19000646.00 6/2/2020 9:53:36 AM COOPER ACADEMY KITCHEN HVAC ADDITION

Fresno Unified School District, **Cooper Academy Elementary School Kitchen HVAC Addition (A#02-118216).**

Please see the following addendum for Mechanical systems.

All revisions to drawings are indicated by cloud and delta No.1

DEMOLITION FLOOR PLAN

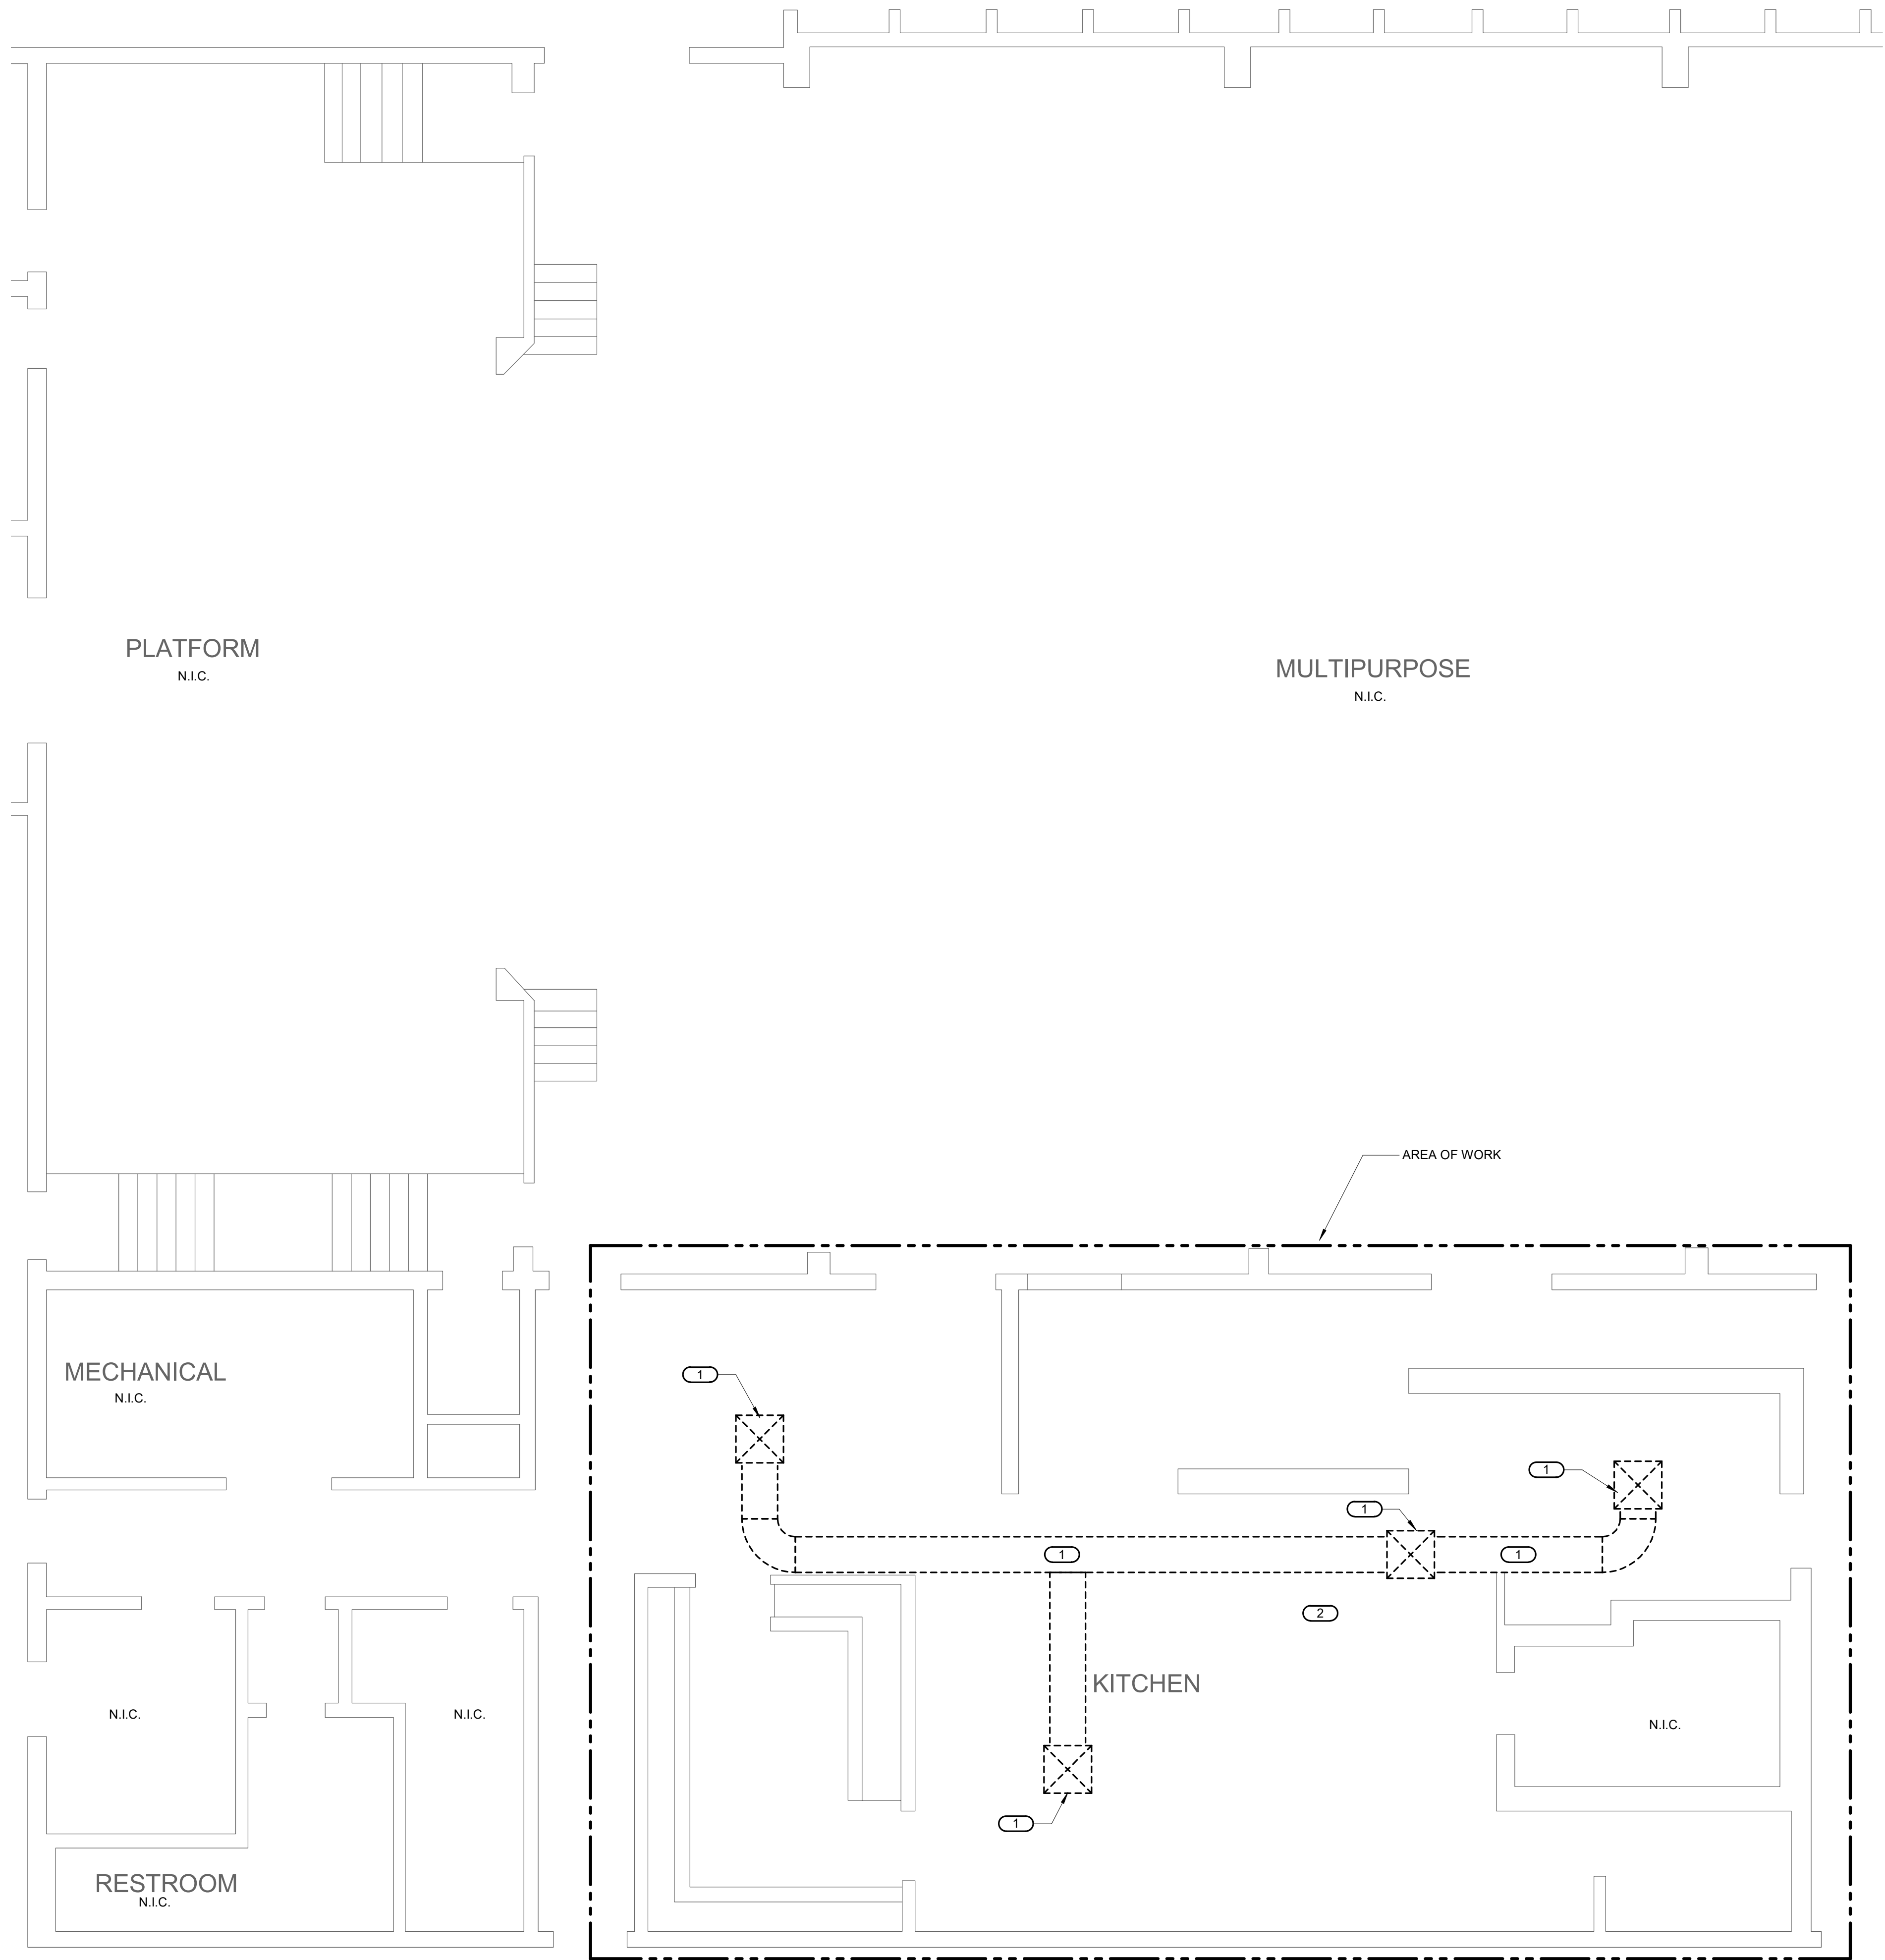
- 1.1 SHEET M2.1
  - A. Added patch and paint general note.
  - B. Modified keynote 2 stating to remove existing power and controls wiring.
- 1.2 SHEET M2.2

1. EXISTING SUPPLY DUCT AND DIFFUSER FOR EXISTING EVAPORATIVE COOLER TO BE DEMOLISHED
2. FIELD LOCATE ELECTRICAL CONTROLS/SWITCHES ASSOCIATED WITH EXISTING EVAPORATIVE COOLER BEING DEMOLISHED AND REMOVE EXISTING POWER AND CONTROLS WIRING, CONDUITS AND SWITCHES. PATCH AND PAINT WALLS AND CEILINGS TO MATCH EXISTING.

DEMOLITION ROOF PLAN

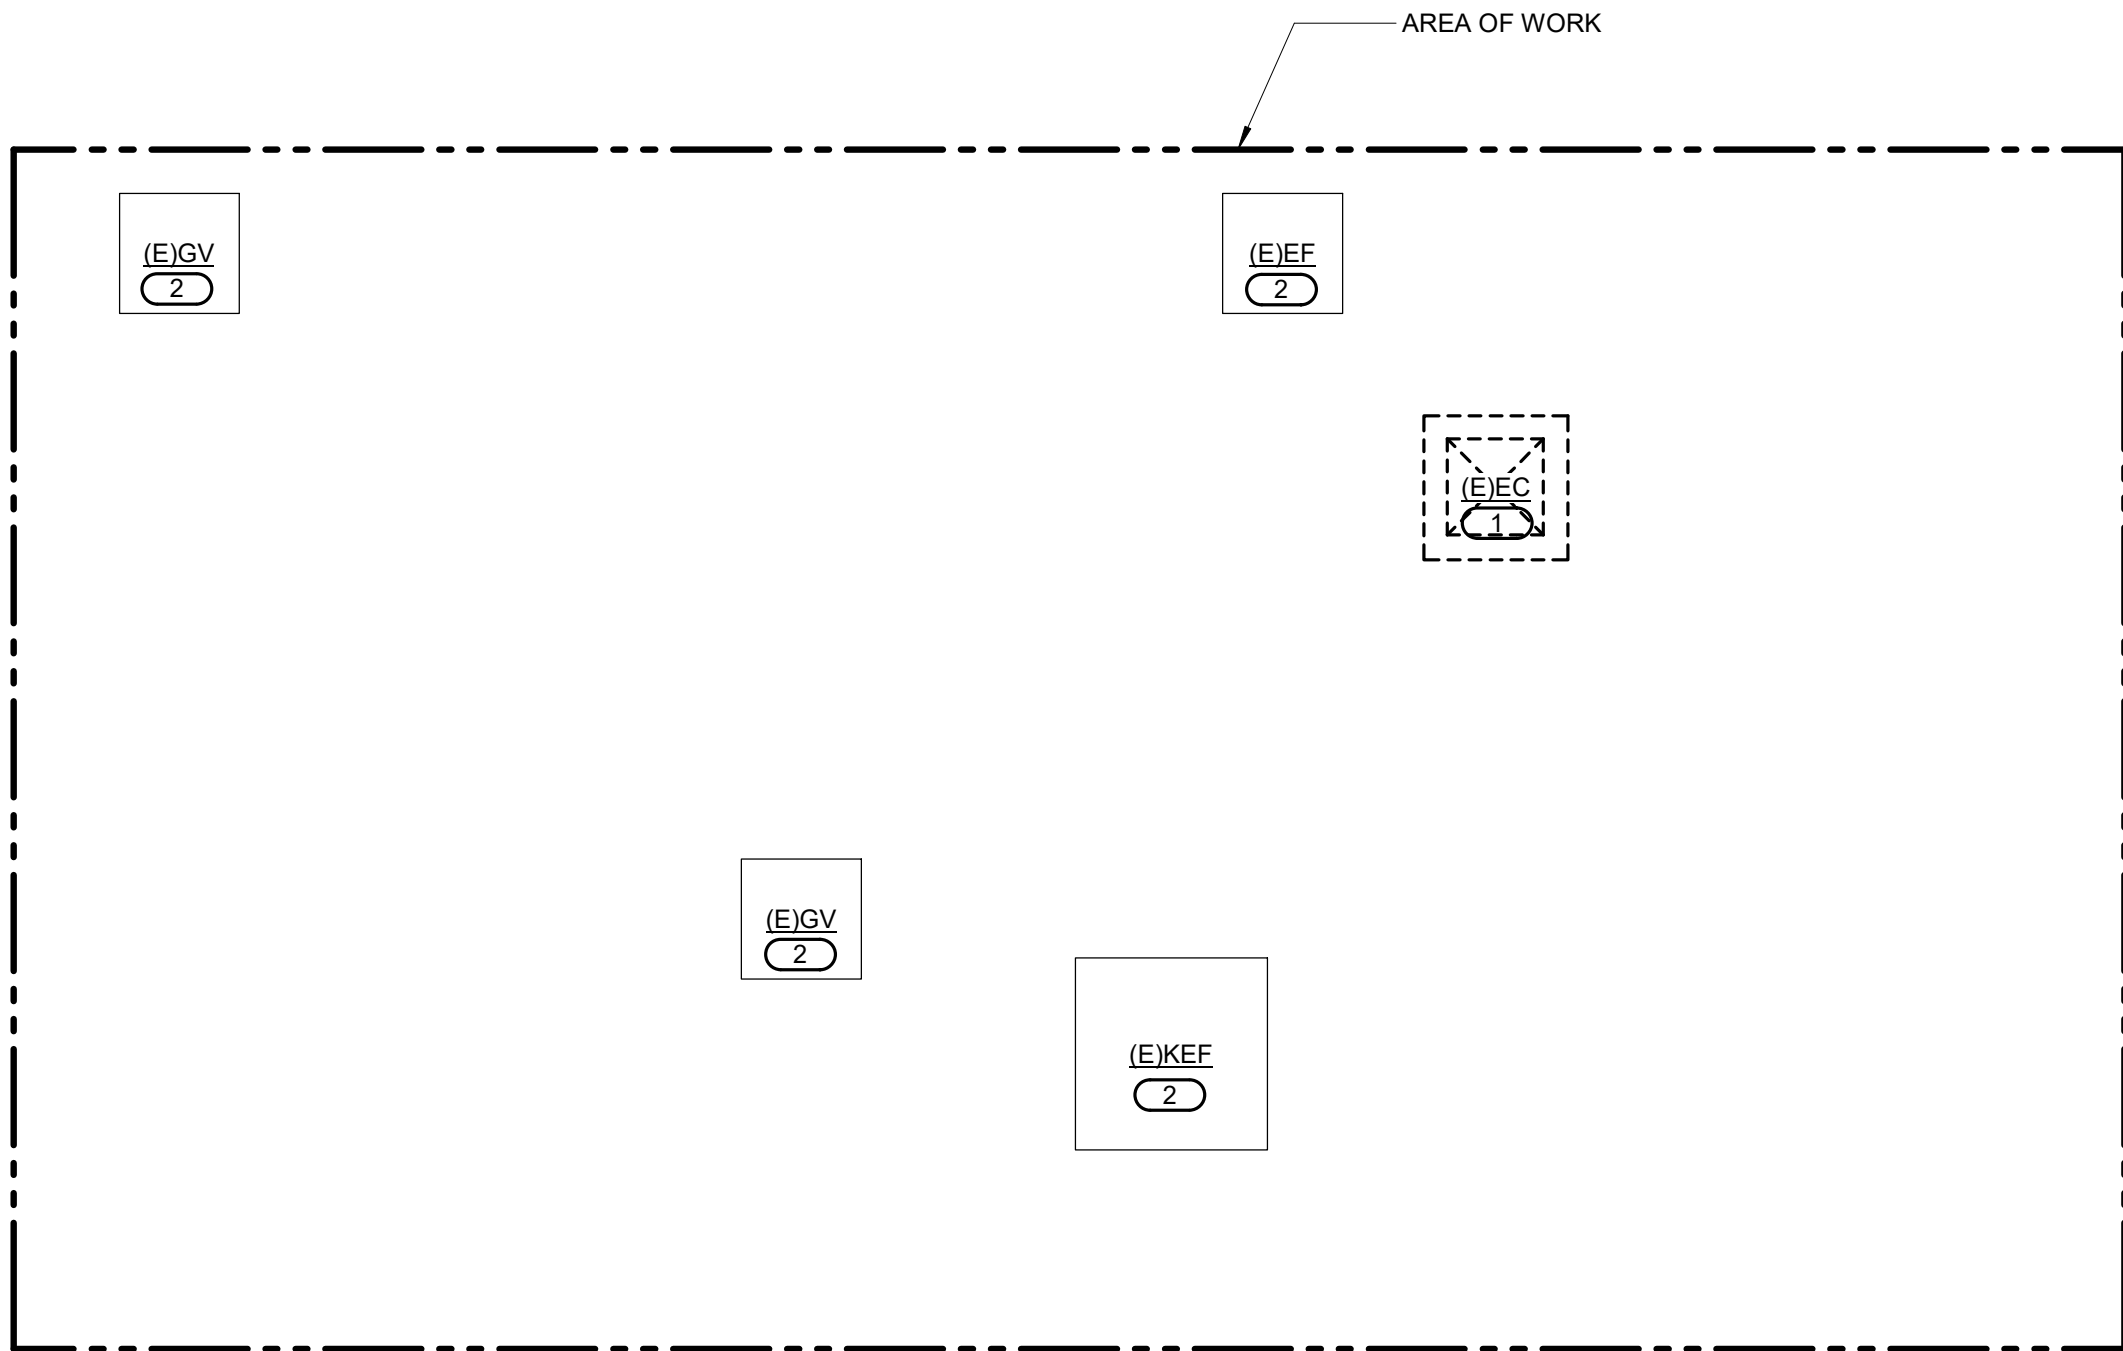
- A. Modified demolition keynotes.
- 1.3 SHEET M3.1
  - A. Modified keynotes.
  - B. Added general note.
- 1.4 SHEET M3.2
  - A. Added keynote 6.
- 1.5 SHEET M4.1

# 1 REMODEL FLOOR PLAN

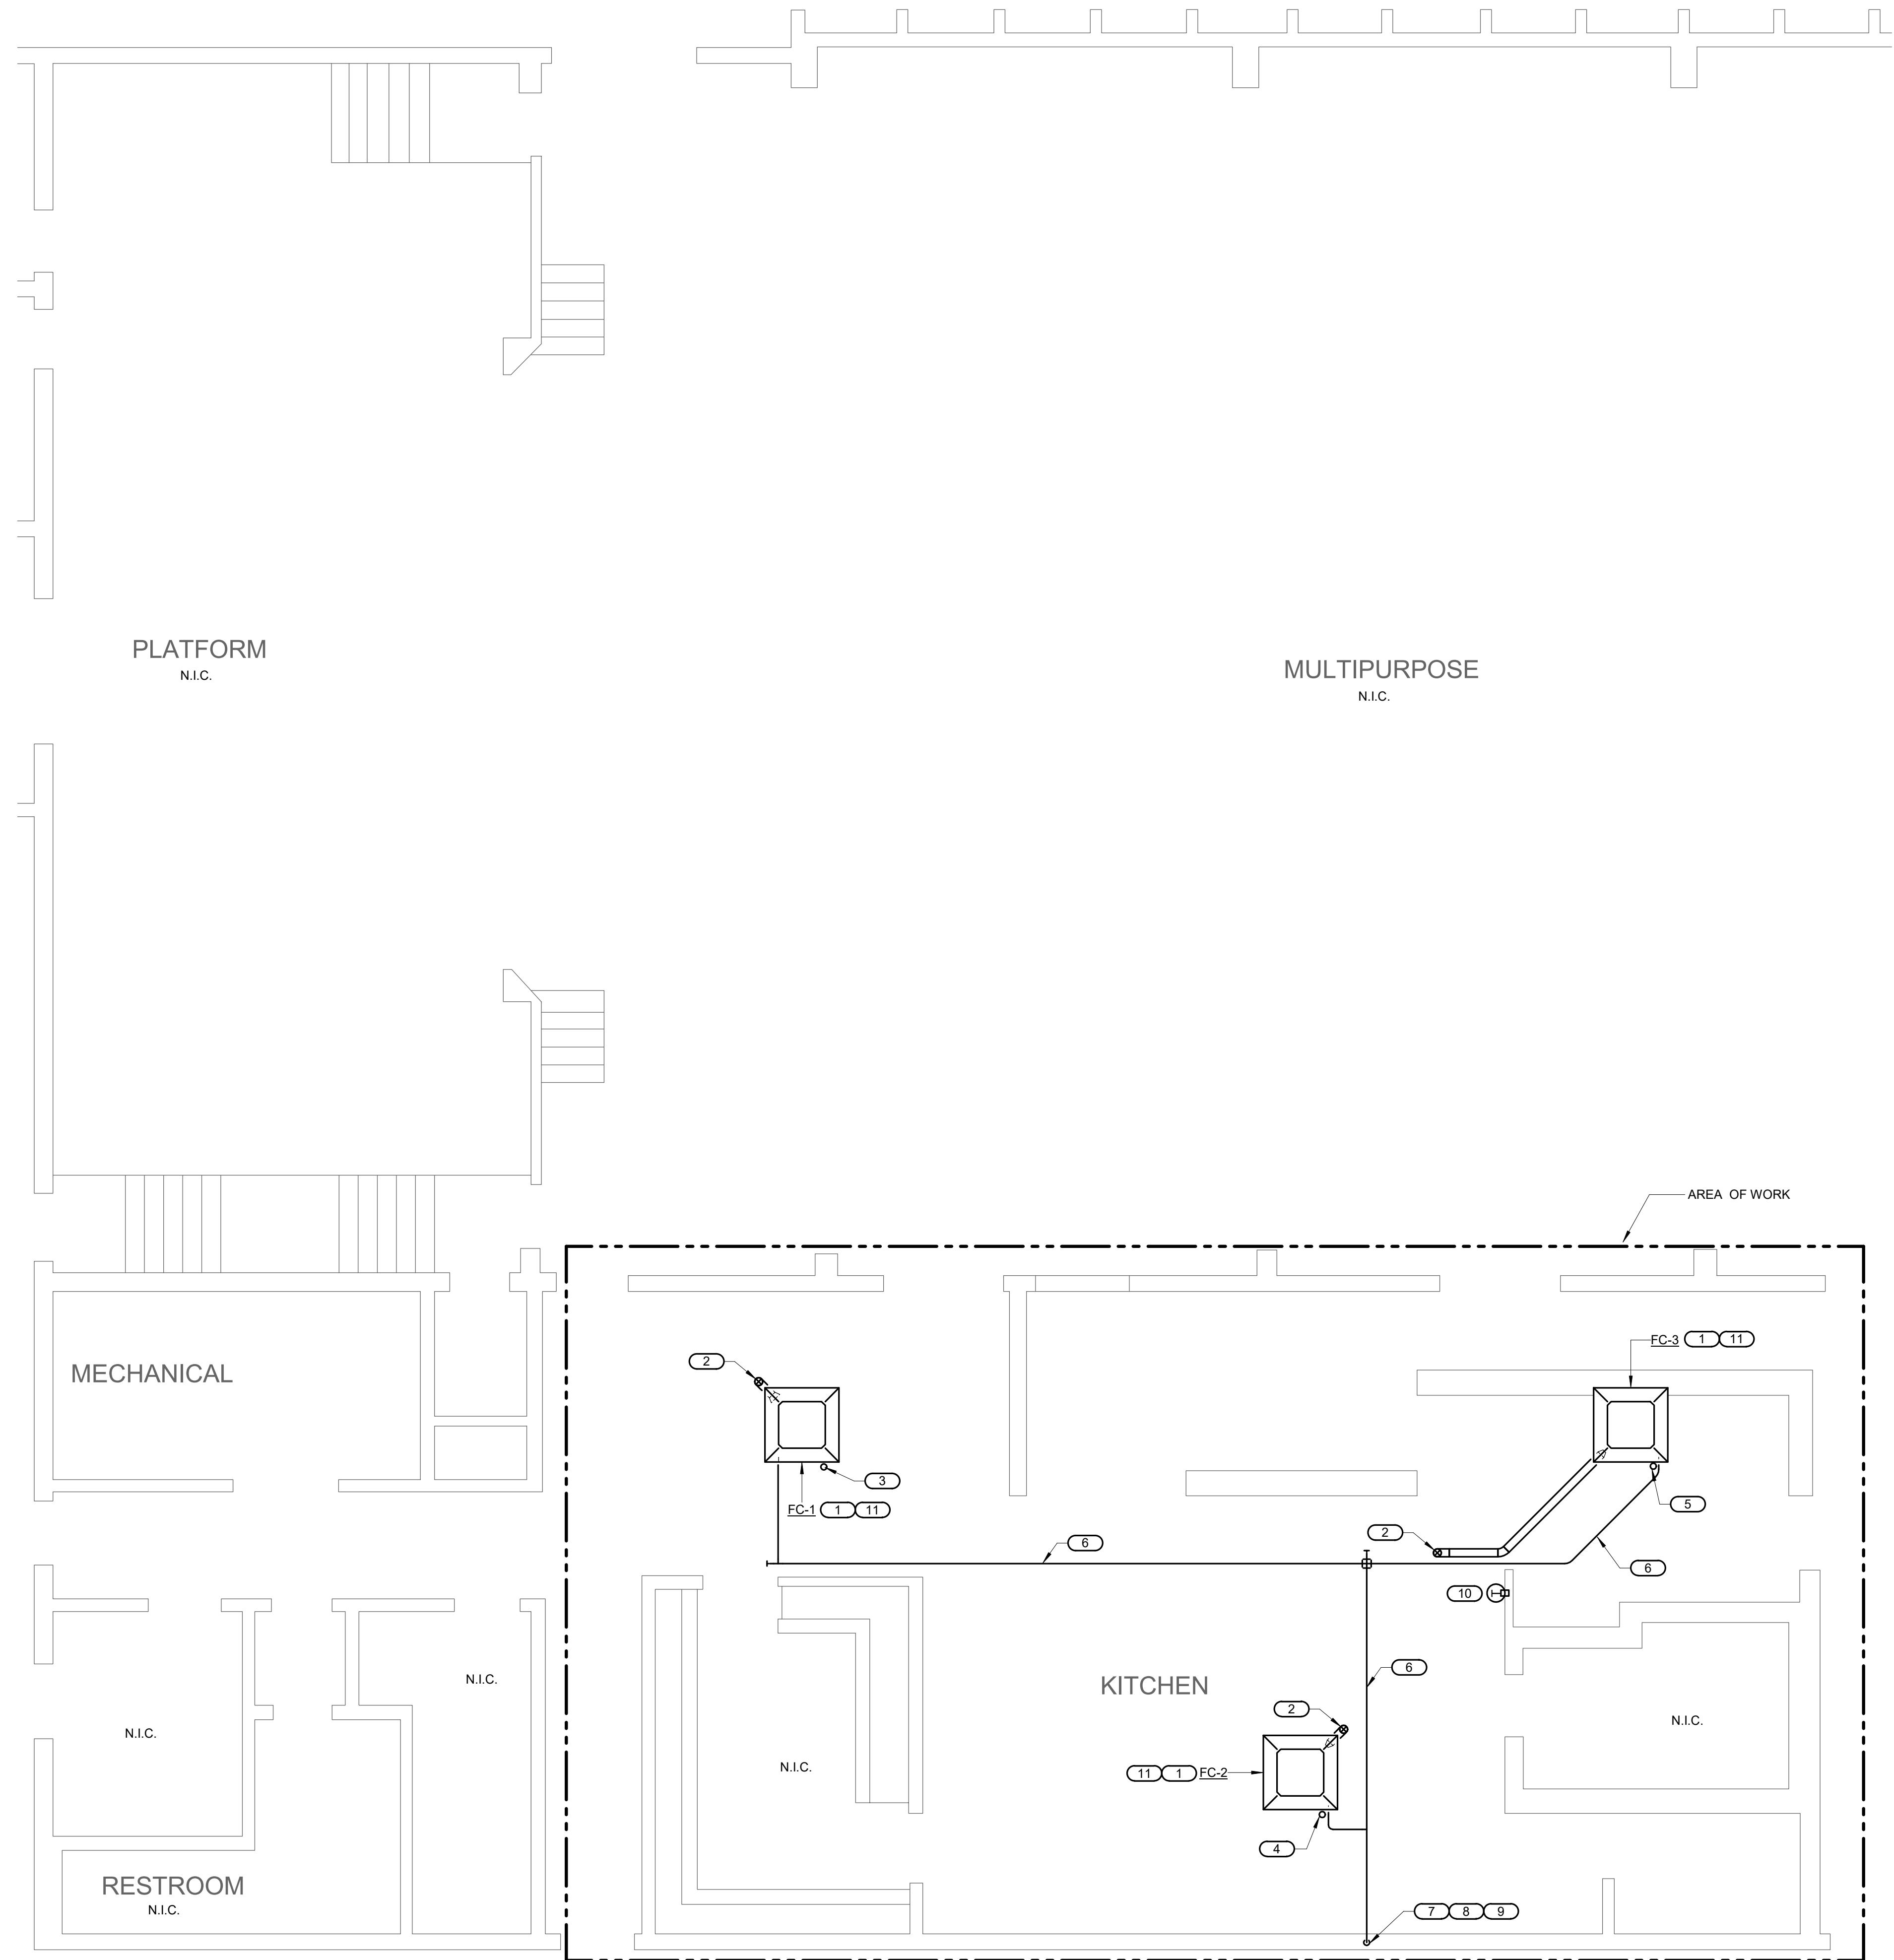
1. NEW FAN COIL TO BE INSTALLED IN EXISTING OPENING IN CEILING.
2. NEW 4"Ø OSA DUCT UTR TO NEW ROOF CAP. REFER TO DETAIL 5/M4.1. BALANCE OSA TO MIN 60 CFM.

7. 3/4" INSULATED CONDENSATE LINE IN (E)WALL. REMOVE DRYWALL BETWEEN STUDS IN ORDER TO INSTALL PIPE IN WALL. PATCH AND PAINT WALL TO MATCH EXISTING AFTER PIPE INSTALLATION.

8. CONNECT CONDENSATE LINE INTO (E)SINK TRAP. INSTALL NEW TRAP WITH CONDENSATE LINE CONNECTION IF NECESSARY. REFER TO DETAIL 6/M4.2.
9. RUN NEW CONDENSATE LINES IN (E)CASEWORK TO (E)SINK. FIELD COORDINATE EXACT ROUTING OF PIPING WITHIN CASWORK TO MINIMIZE DISRUPTION AND SPACE CONSIDERATION.

1. WHERE ANY DEMOLITION REQUIRES PATCH AND PAINT OF EXISTING WALLS AND CEILINGS. THE PAINT SHALL BE CORNER TO CORNER FOR COMPLETE COVERAGE.
